Subject: Response to October 17, 2008 Letter from ACEH  
St. Francis Pie Shop UST Site, 1125 67<sup>th</sup> Street Oakland, California  
ACDEH Site No. RO2602, Global ID: T0600109444

Subject: Response to October 17, 2008 Letter from ACEH  
Former St. Francis Pie Shop UST Site  
1125 67<sup>th</sup> Street Oakland, Ca  
ACEH Site No. RO2602

The following numbered responses correspond to the numbered technical comments provided in the October 17, 2008 ACEH letter.

DESIGNED BY:	CHECKED BY: JEG	<b>SITE PLAN</b>	DATE: 05/10/2010	FIGURE: 1
DRAWN BY: JEG	SCALE:			
PROJECT NO: 320-01-01		ST. FRANCIS PIE SHOP UST SITE 1125 67TH STREET OAKLAND, CALIFORNIA

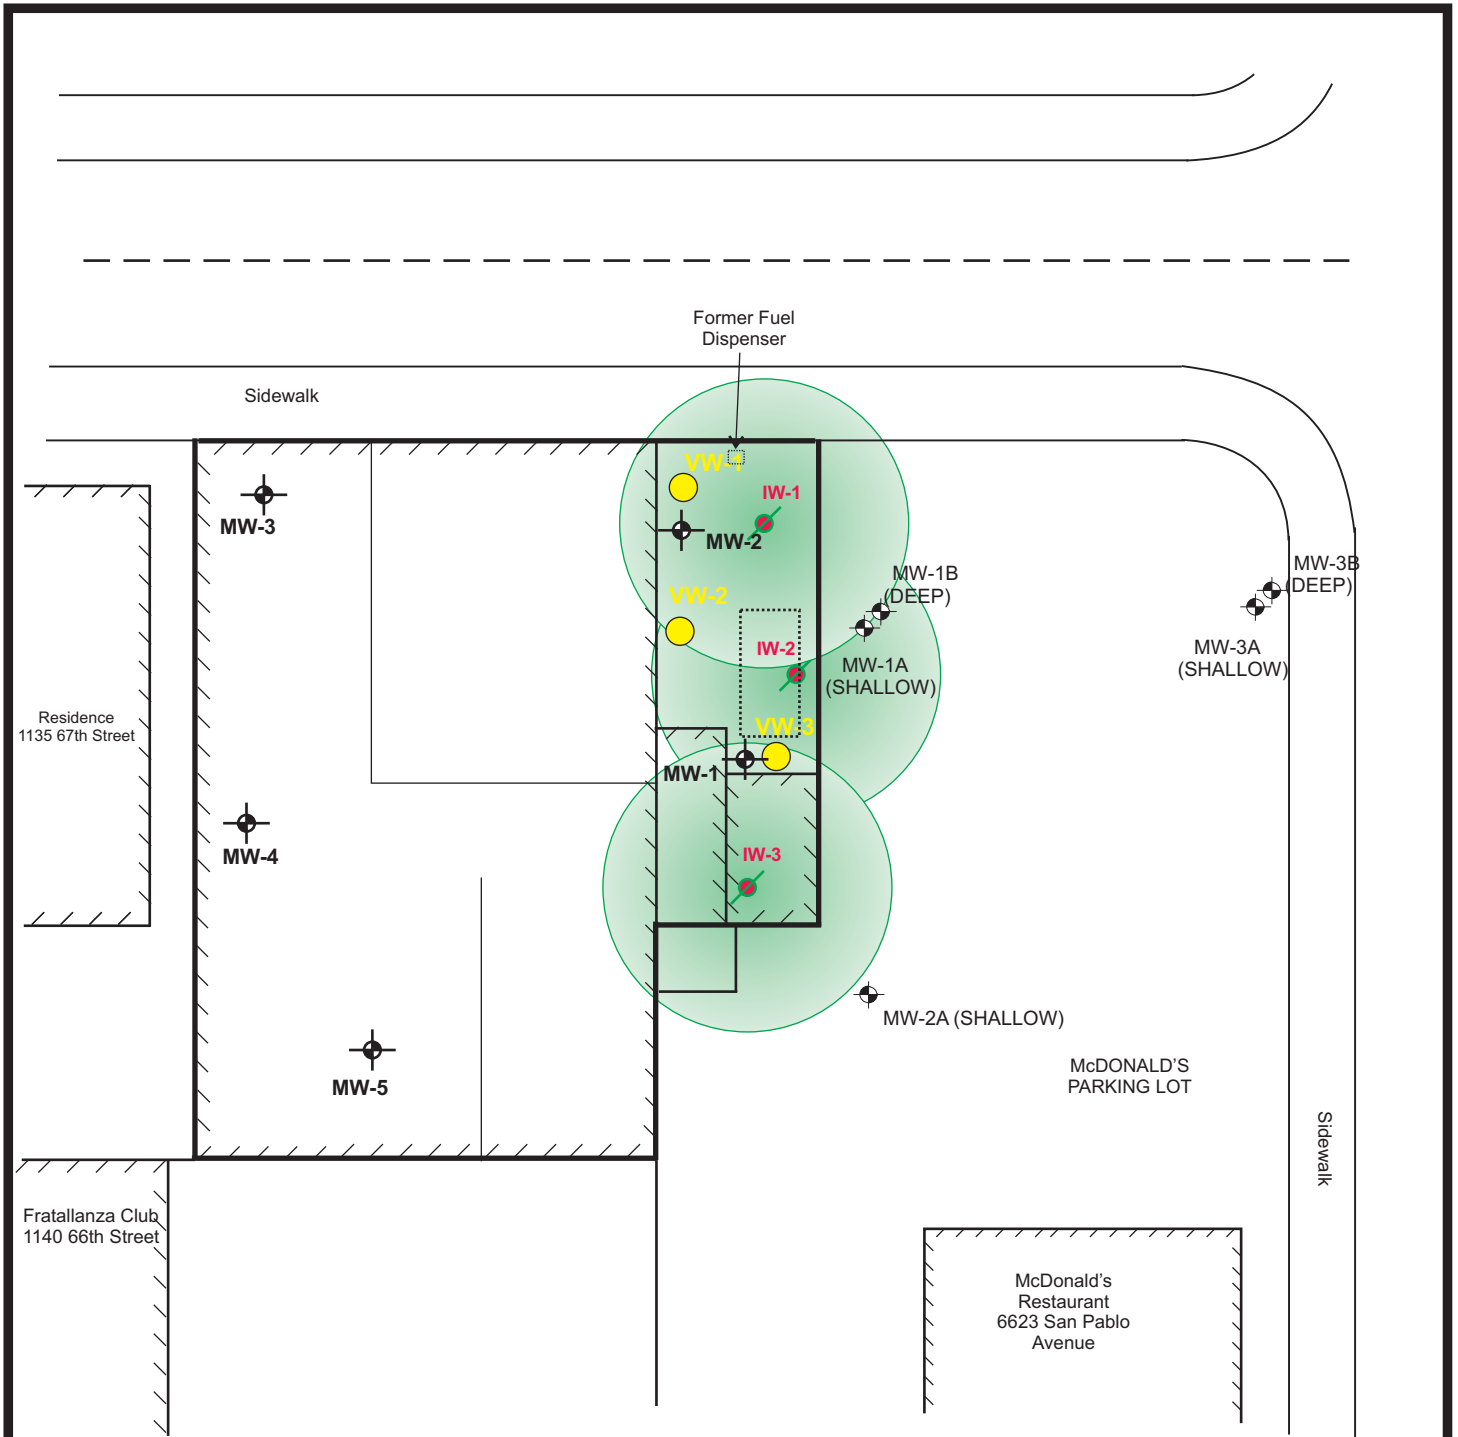
Gribi Associates is pleased to submit this letter on behalf of St. Francis Pie Shop for the underground storage tank (UST) site located at 1125 67<sup>th</sup> Street in Oakland, California (see Figure 1). Gribi Associates previously submitted *Remedial Investigation Report and Workplan To Conduct Ozone Injection Pilot Test* (May 10, 2007) and *Revised Workplan to Conducted Ozone Injection Pilot Test* (August 6, 2008) proposing to conduct an ozone injection pilot test at the site. On October 17, 2008, Alameda County Environmental Health (ACEH) issued a letter requesting additional clarification relative to the planned ozone injection pilot test. The goal of this letter is to address each of the specific comments/requests so that the pilot test can be implemented.

DESIGNED BY:	CHECKED BY: JEG	<b>PROPOSED PILOT TEST WELL LOCATIONS</b>	DATE: 05/10/2010	FIGURE: 2
DRAWN BY: JEG	SCALE:			
PROJECT NO: 320-01-01		ST. FRANCIS PIE SHOP UST SITE 1125 67TH STREET OAKLAND, CALIFORNIA

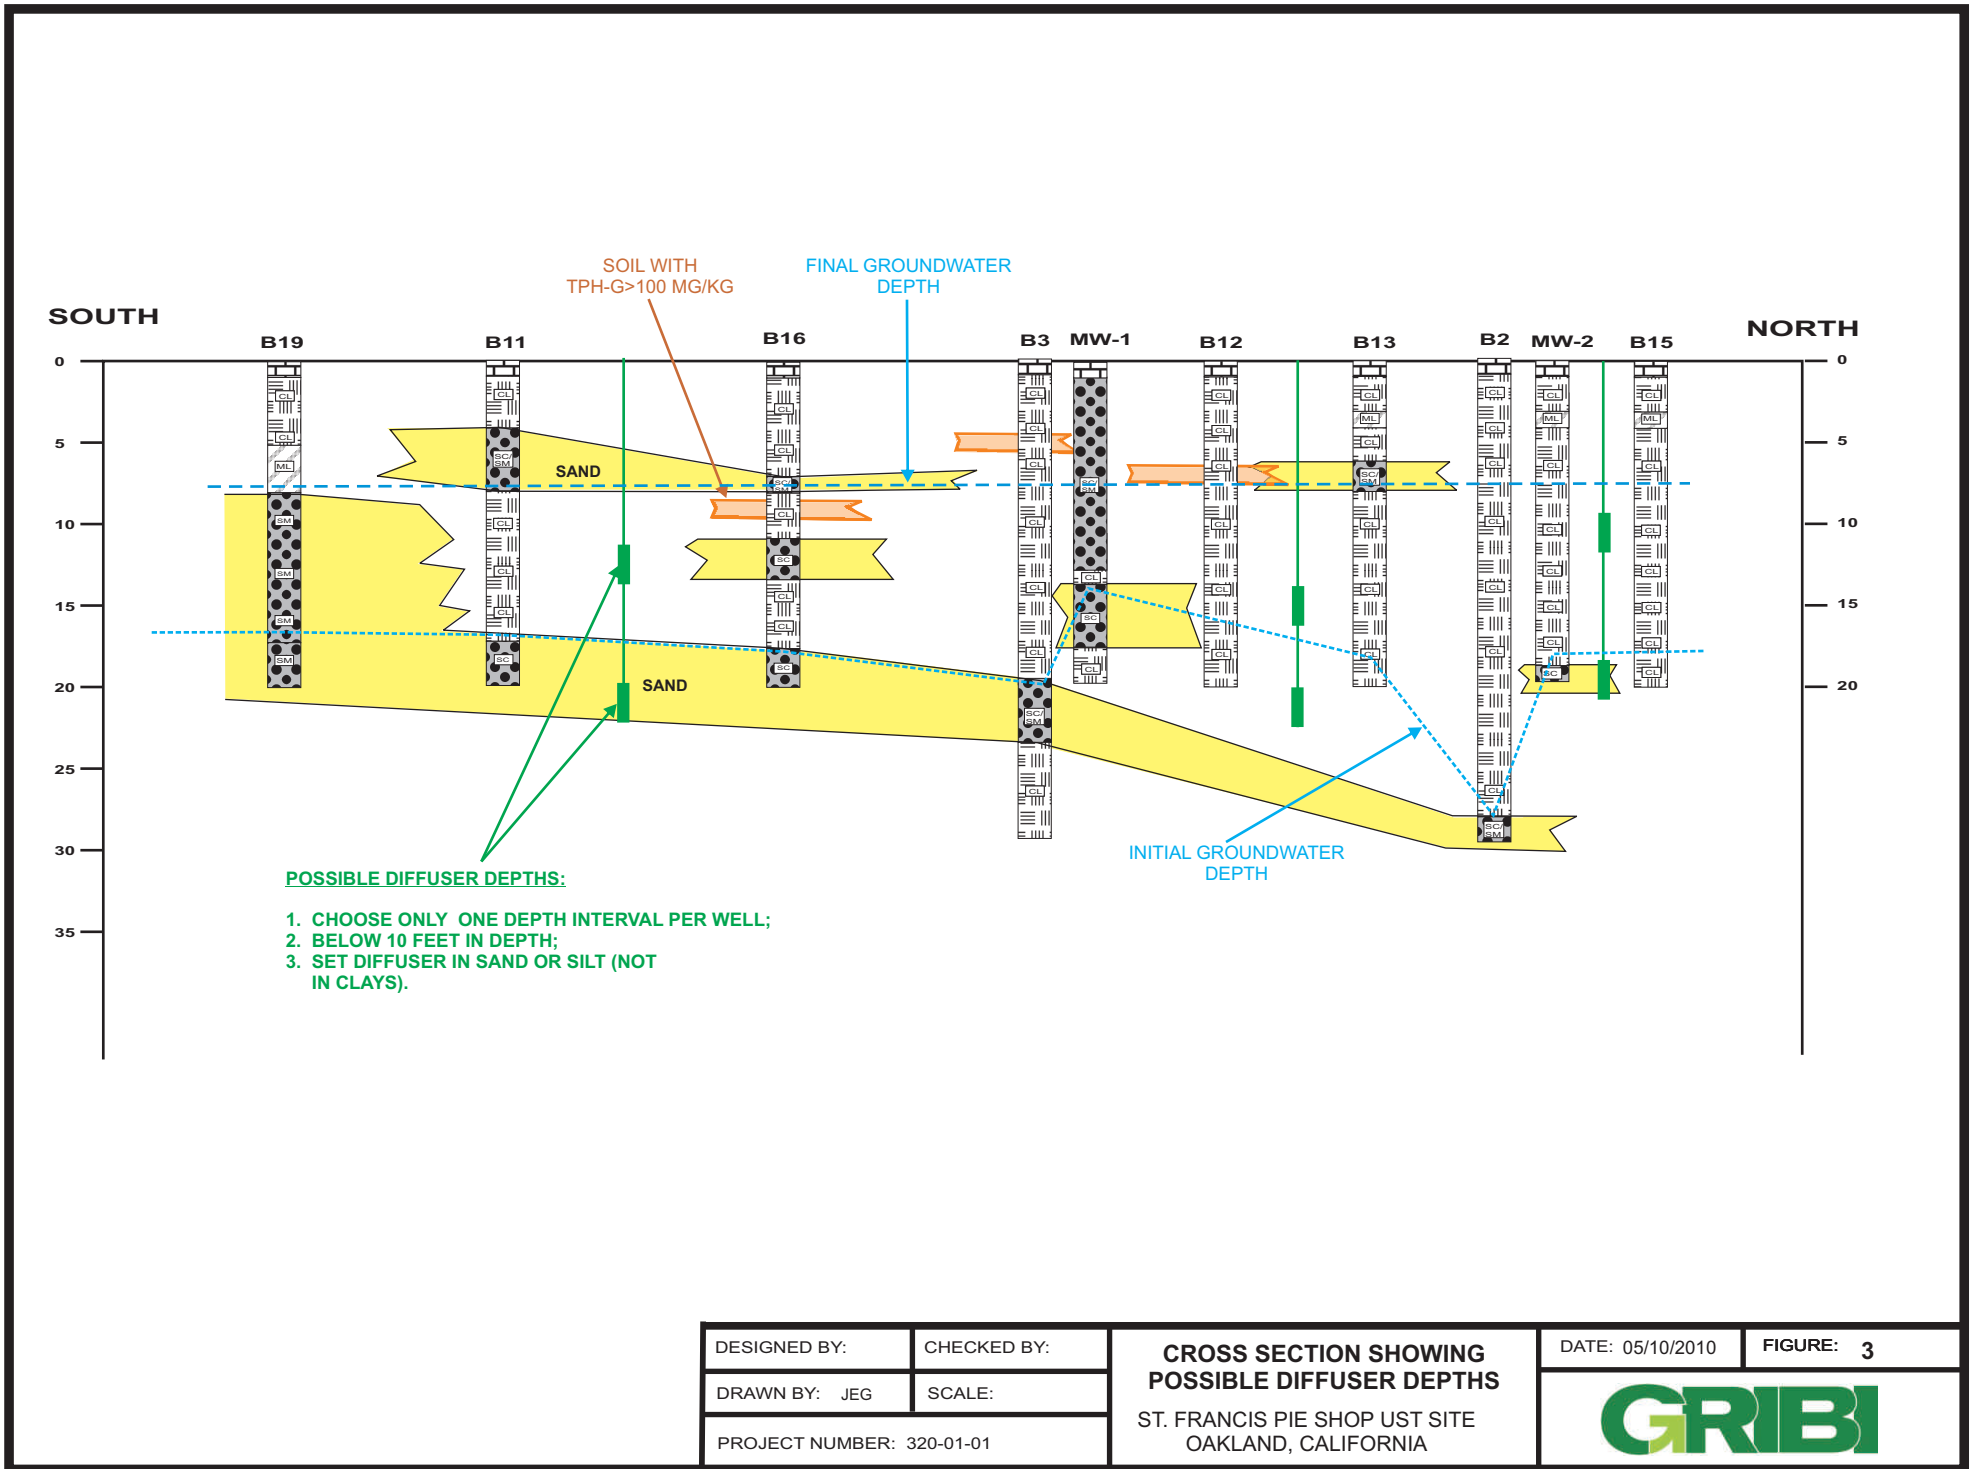
1. **Ozone Sparge Injection Point Spacing and well depths.**

*Well spacing:* As shown on Figure 2 (and on Figure 9 in the revised workplan), the distance from IW-1 to IW-2 is approximately 30 feet, and the distance between IW-2 and IW-3 is approximately 45 feet. Based on our experience on several ozone injection remediation projects, these proposed distances are reasonable.

**CROSS SECTION SHOWING  
POSSIBLE DIFFUSER DEPTHS**

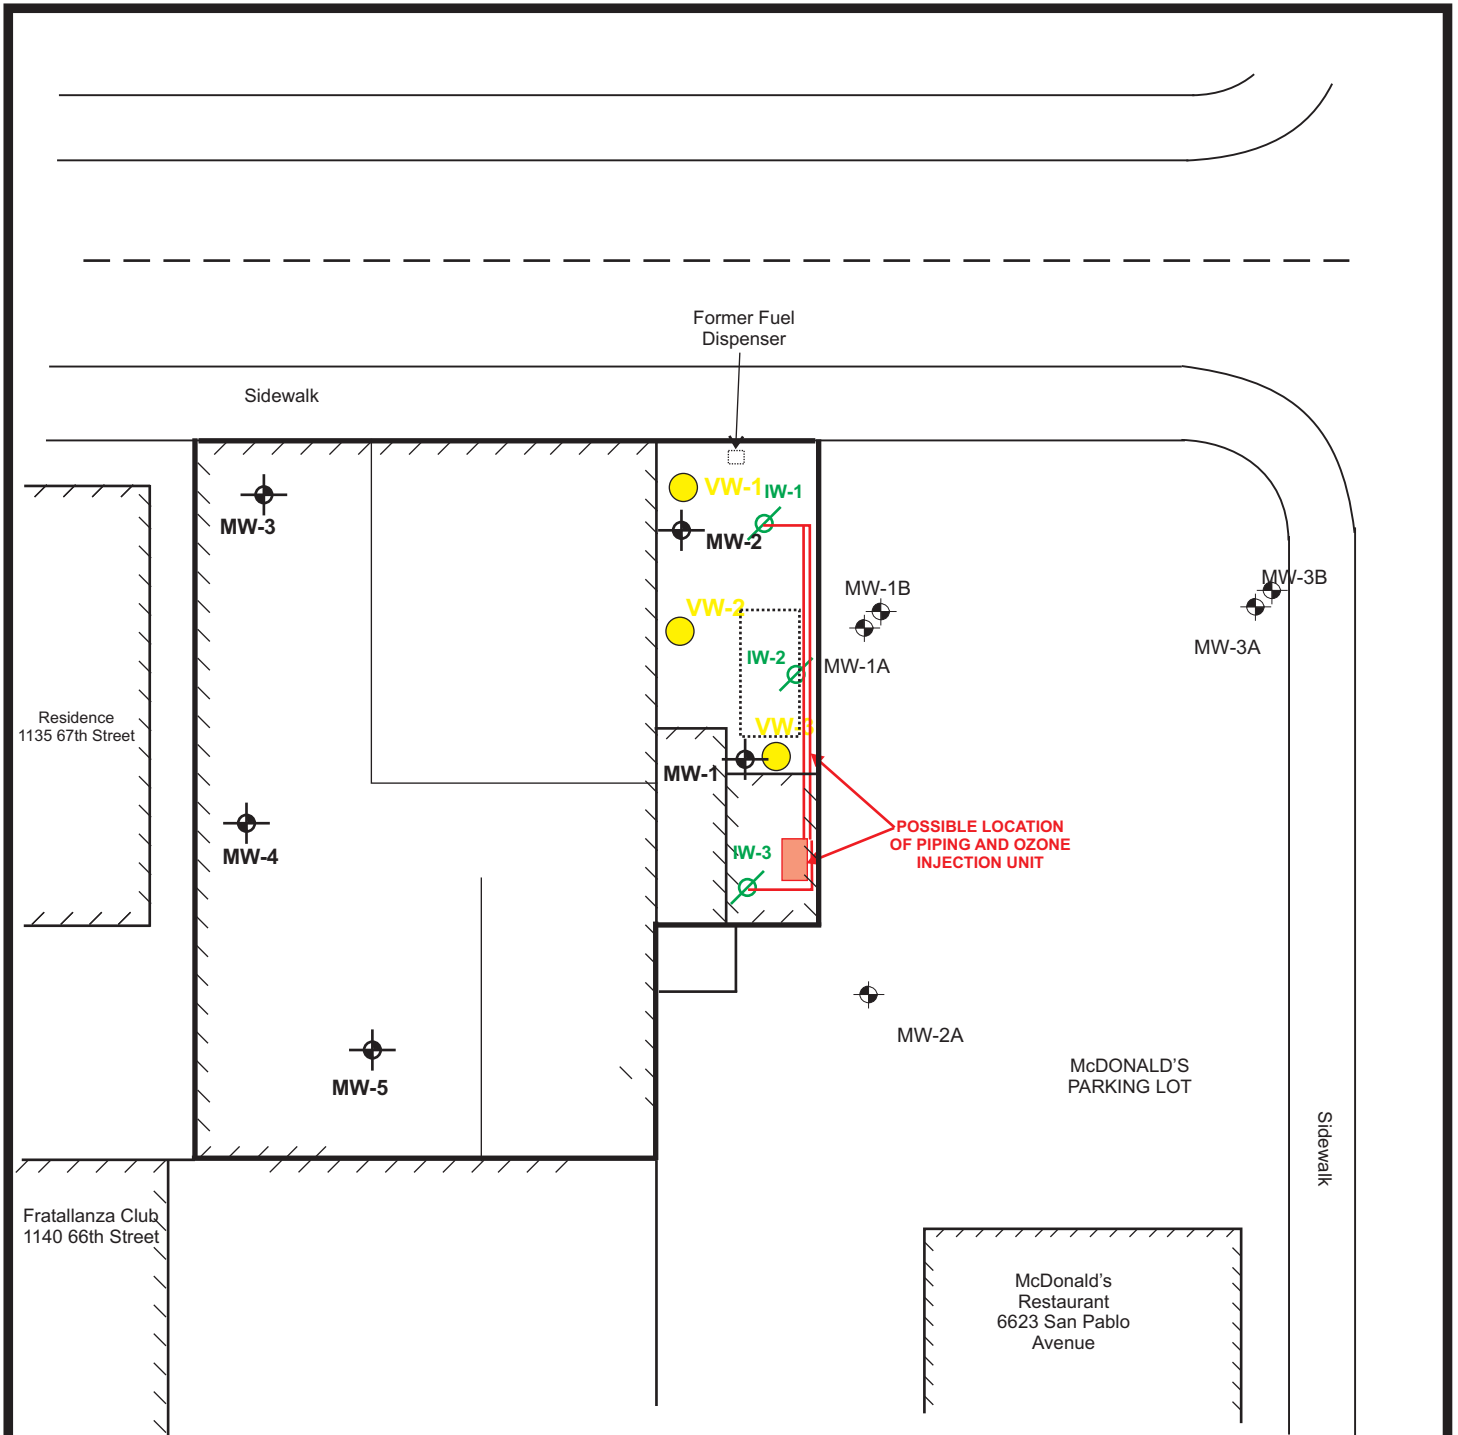
*Revise Cross Section:* We have provided a north-south cross section in Figure 3 that includes possible ozone injection diffuser depths for the pilot test, along with other subsurface features.

*Well depths:* We generally concur with this comment. Ozone injection well diffusers are normally placed at least five to ten feet below the water table to allow for wider dispersion of upwelling ozone. However, this site has a relatively large amount of clays, with discontinuous sand layers (see Figure 3). Thus, perhaps the best way to decide on diffuser depths is on a well-by-well basis. For each well, we will core to at least 25 feet

using direct-push continuous coring equipment. After logging soils in the boring, we will select a diffuser depth based on the following rules:

**Are sands present between 10 and 25 feet bgs?:**

- If yes, then set diffuser in first sand layer below 10 feet in depth;
- If no, then set diffuser in most permeable layer below 10 feet.

DESIGNED BY:	CHECKED BY: JEG	<b>PROPOSED OZONE INJECTION SYSTEM LAYOUT</b>  ST. FRANCIS PIE SHOP UST SITE 1125 67TH STREET OAKLAND, CALIFORNIA	DATE: 05/10/2010	FIGURE: 4	
DRAWN BY: JEG	SCALE:				
PROJECT NO: 320-01-01

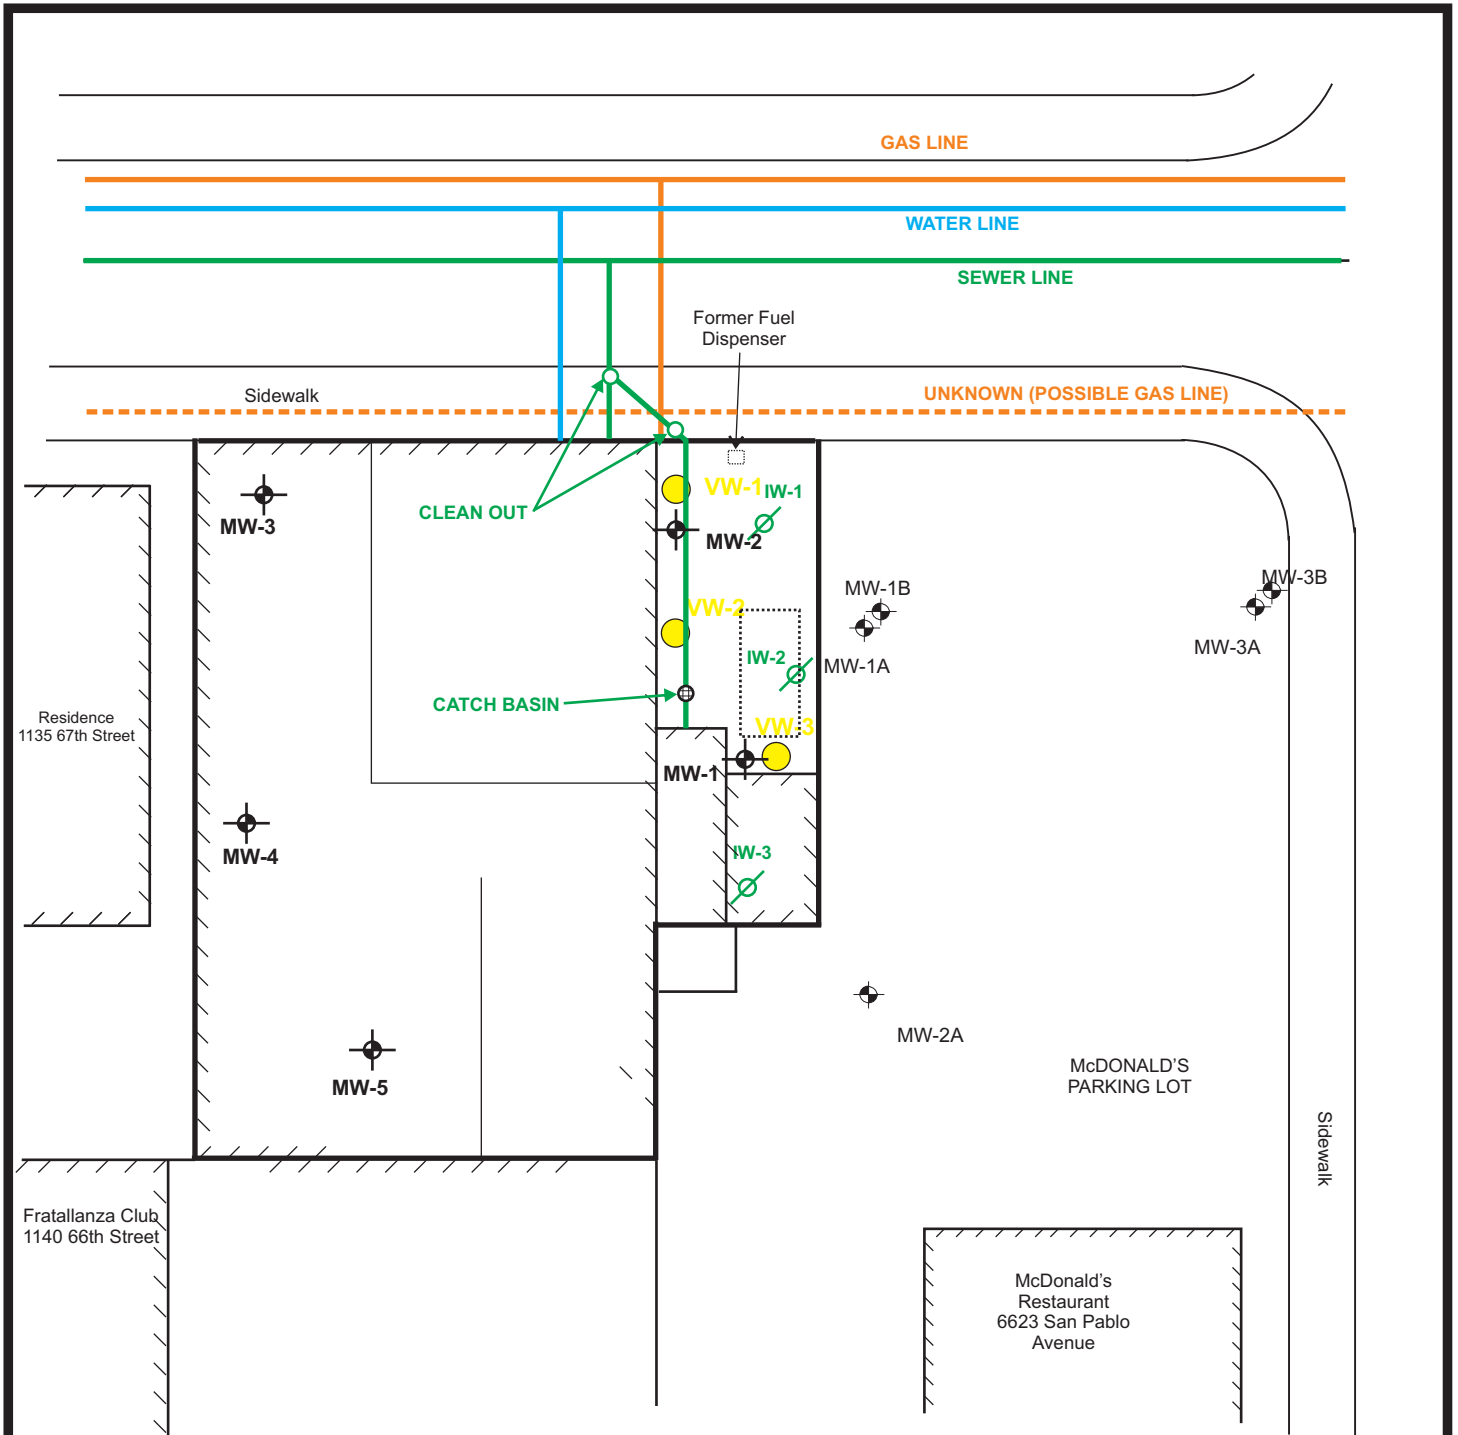
*Map of Piping Layout:* The ozone generation unit and piping will be located in the yard area on the east side of the site. The ozone unit is trailer-mounted and mobile, so the exact location of the ozone unit could vary depending on tenant considerations; however, the location of the ozone unit will also be chosen to minimize piping distances (based on our experience, the site remediation area is small enough such that distance from well to treatment unit will not be a significant concern). In order to reduce costs, we will attempt to run piping above ground. Given these considerations, the exact configuration of the pilot test system layout is not fixed; however, Figure 4 shows an approximate remediation system layout.
